ZONING PLAN FOR:
DAVID PEARSON COMMUNITIES
PROPERTY IS LOCATED IN LAND LOT 629 & 630
IN THE 16TH DISTRICT, 2ND SECTION
COBB COUNTY, GEORGIA
SCALE: 1" = 50'. DATE: APRIL 21, 2014

PETITION NO: Z-48

ZONING COMMENTS:

Z-48 (2014)
Previous Zoning
Minutes/Analysis

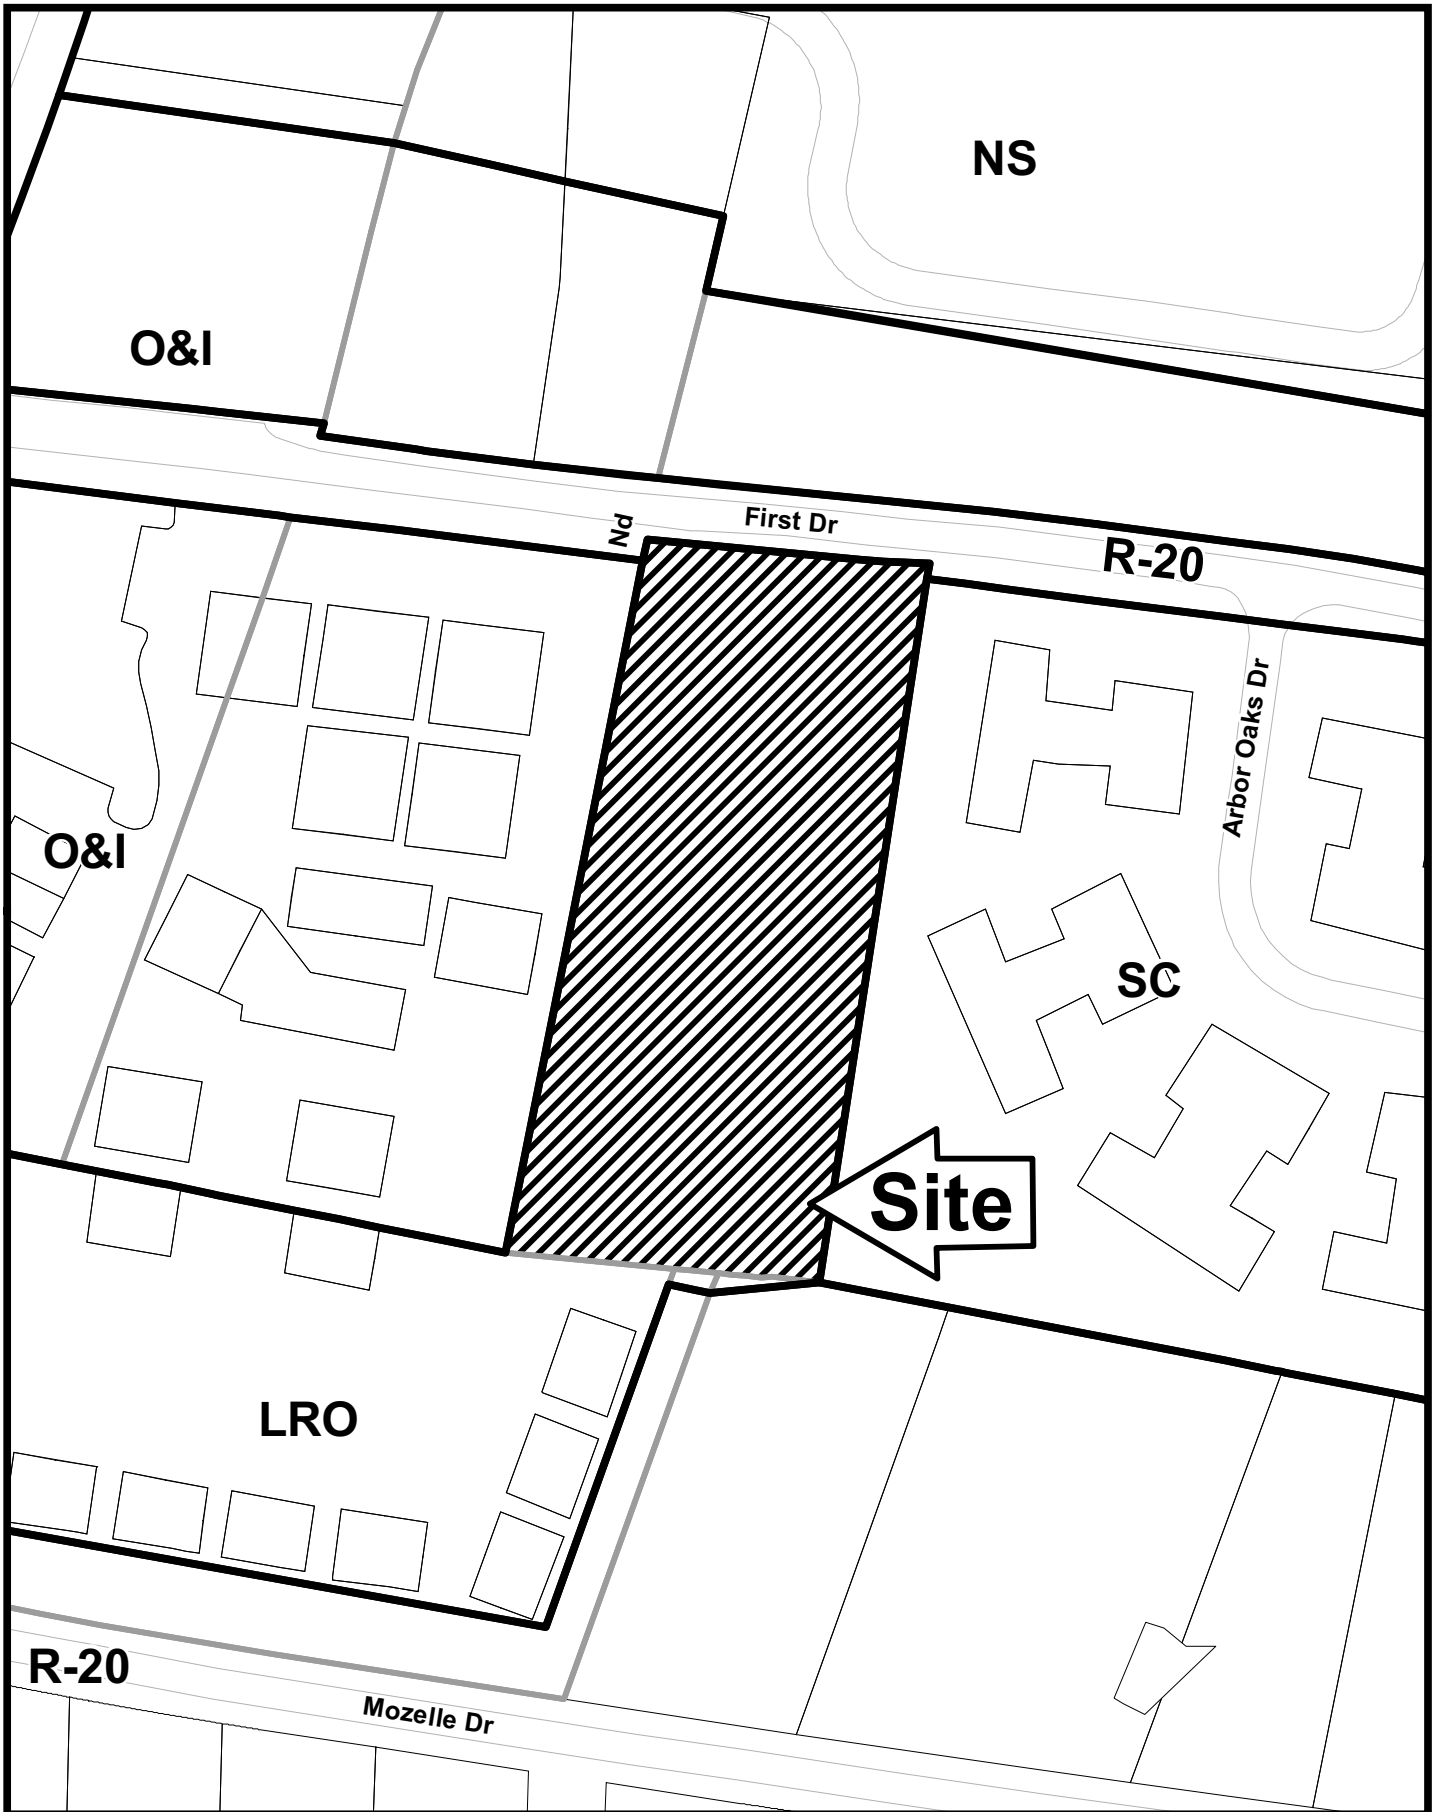
The site plan indicates a private street is planned and the applicant requests that the setbacks for the development be geared toward the private street, instead of First Drive. This will require granting a waiver of the front setback along the private street from 25 feet to 13 feet; waiving the rear setback abutting the eastern property line from 35 feet to 20 feet.

When projects contemplate less than 20 foot separation between units, guest parking shall be provided or the streets shall be labeled as a fire lane.

Additional Sewer to be private in private street
Comments:

- No Stormwater controls shown _____
- Copy of survey is not current – Additional comments may be forthcoming when current site conditions are exposed.
- No site improvements showing on exhibit.

1. This site is located on First Drive between Sandy Plains Executive Center to the west and the Arbor Oaks Suburban Condominium development to the east. The entire site drains to the east through the Arbor Oaks development. With the proposed layout a drainage easement will be required along the rear of all the lots to adequately control runoff from the site. Since it appears that underground detention will be utilized under the private street, it may be necessary to relocate the street to the low-side of the site, adjacent to Arbor Oaks, to adequately control site runoff.

2. The detention pond for the adjacent Sandy Plains Executive Center discharges through an existing pipe along the southern boundary of this site. An adequate drainage easement must be provided for this conveyance.

First Drive is classified as a local and according to the available information the existing right-of-way does not meet the minimum requirements for this classification.

Recommend curb, gutter, and sidewalk along the First Drive frontage.

Recommend private streets be constructed to the Cobb County Standard Specifications.

- A. It is Staff's opinion that the applicant's rezoning proposal will not permit a use that is suitable in view of the use and development of adjacent and nearby properties. The subject property is bordered by suburban condominiums to the east an office development to the west and single-family houses to the southeast.

Based on the above analysis, Staff recommends DELETING the request to RA-5 subject to the following conditions:

- Site plan to meet all RA-5 requirements;
- Detached, single-family houses only;
- Fire Department comments and recommendations;
- Water and Sewer Division comments and recommendations;
- Stormwater Management Division comments and recommendations;
- Department of Transportation comments and recommendations; and
- Owner/developer to enter into a Development Agreement pursuant to O.C.G.A. §36-71-13 for dedication of system improvements to mitigate traffic concerns.
